RE: Groundwater Discharge Plan – Artesia PTU LLC, Permit Application for a Discharge Permit – Response to Notice of Administratively Incomplete Discharge Permit Renewal Application

**ATTACHMENT 1**  
**RESPONSE AND CROSS-REFERENCE TABLE**

# Groundwater Discharge Plan

Artesia PTU LLC  
Artesia, New Mexico

2-1 Facility Site Plan

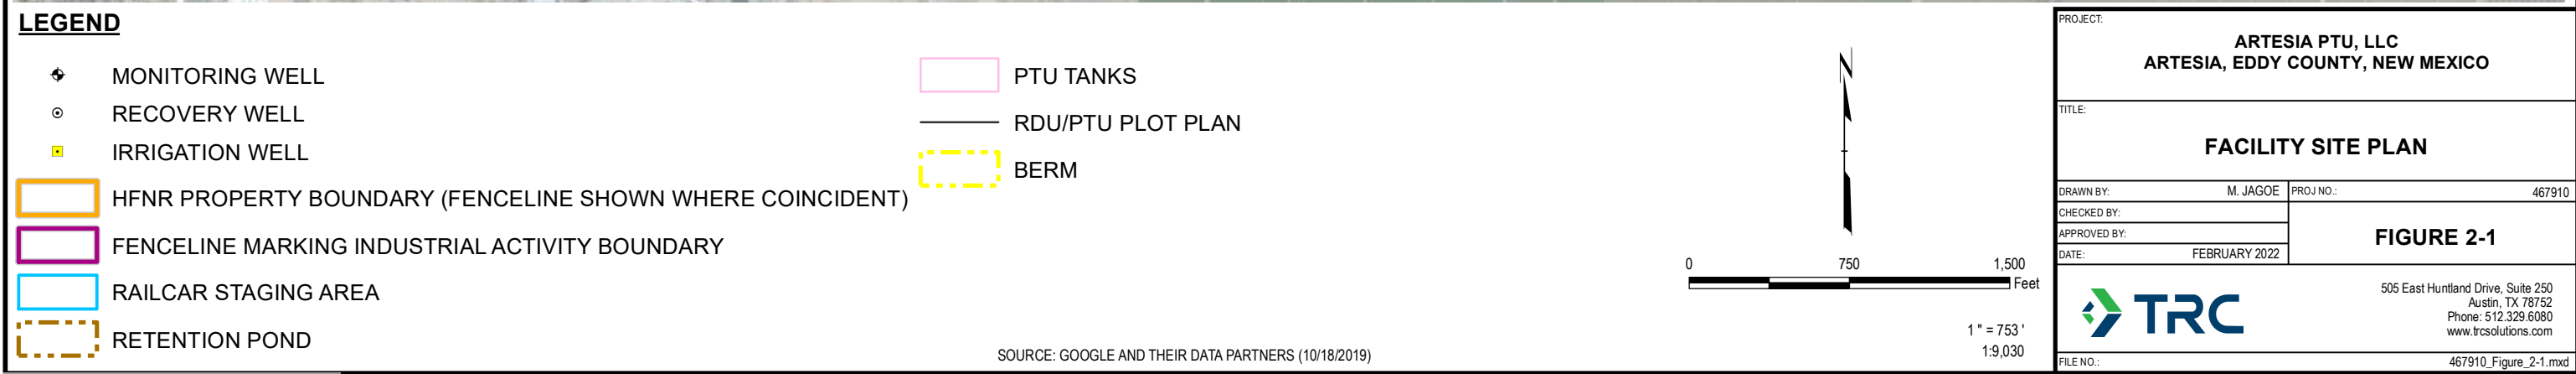
2	In Figure 2-1, identify all locations of the tanks listed in Table 4-1 (PTU Storage Tanks and Containers). This figure only shows the location for a select number of tanks.	<p>Figure 2-1 has been updated to show the locations of the tanks listed in Table 4-1.</p> <p>Table 4-1 has been modified to provide the correct list of tanks and their locations within the PTU Facility. Various tanks listed in the previous version of Table 4-1 have been added, removed, or modified to either correct typographical errors, to remove RDU tanks that were incorrectly included, or to reflect the current state of the PTU as it is still undergoing construction and planning (i.e., revising tank numbers to include newly numbered tanks).</p>	Figure 2-1, Table 4-1.

3-1 Facility Water Sources

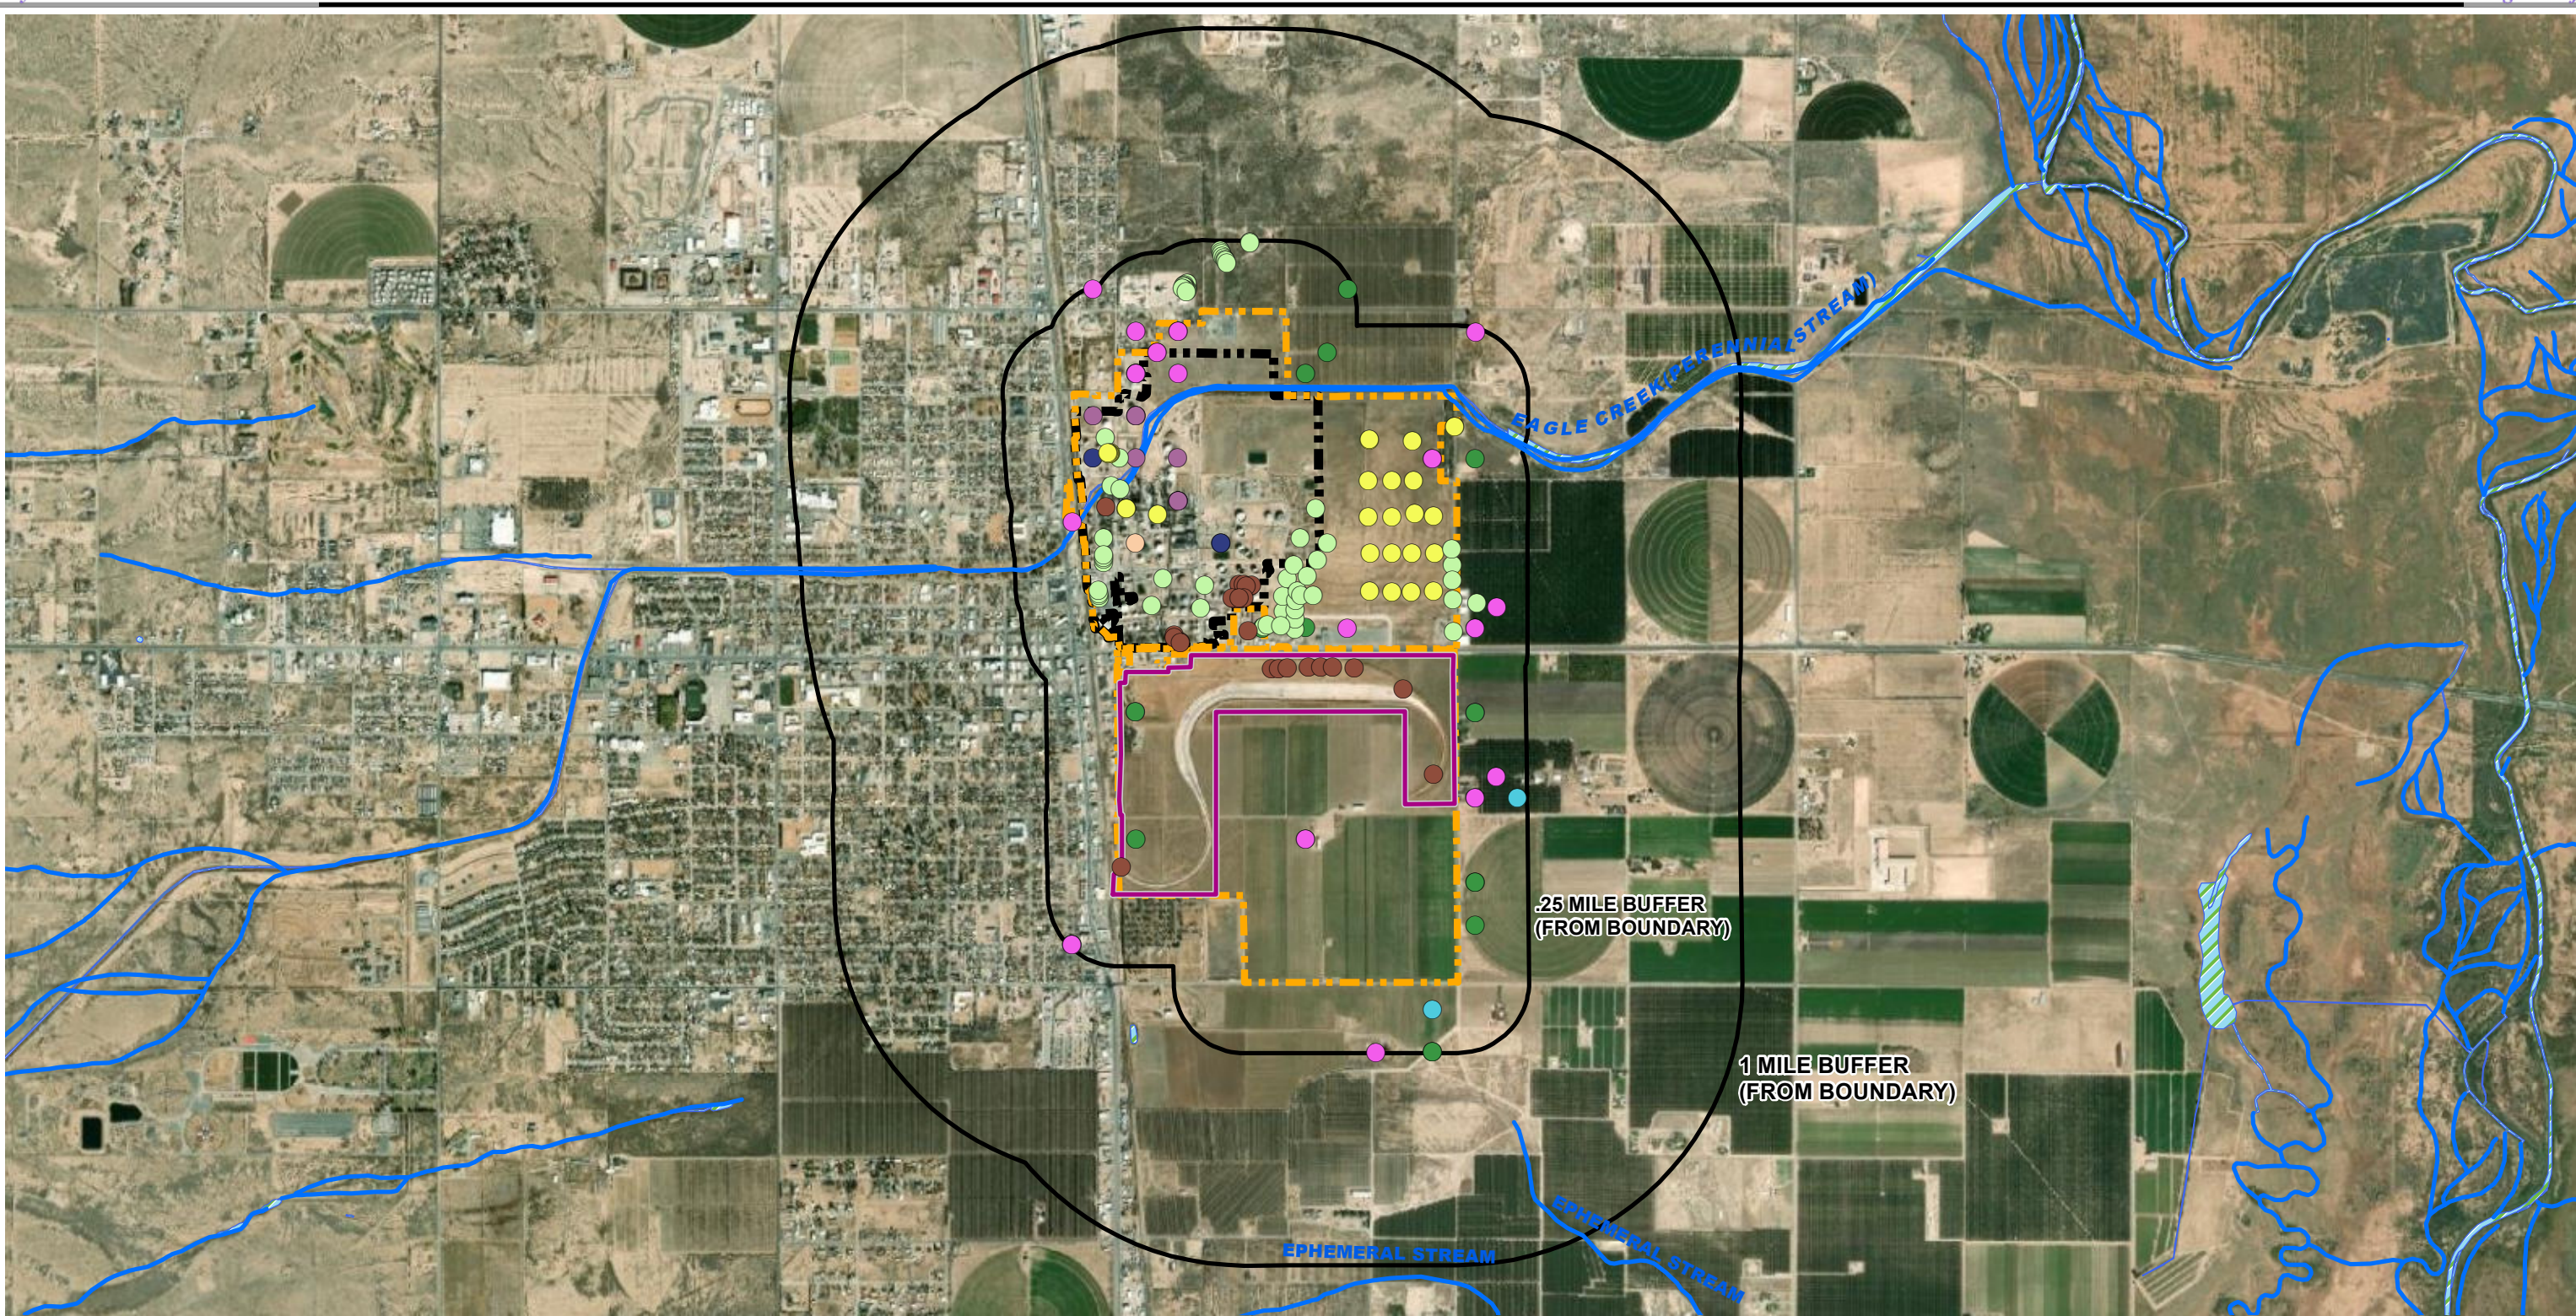
NA	NA	The OGRID Number for the PTU has been added to the application in Section 2.1.	Section 2.1
NA	NA	The wetlands provided on Figure 3-1 have been revised, as the wetlands previously presented on Figure 3-1 were incorrect. The US Fish and Wildlife Services National Wetlands Inventory was reviewed to correct this error.	Figure 3-1
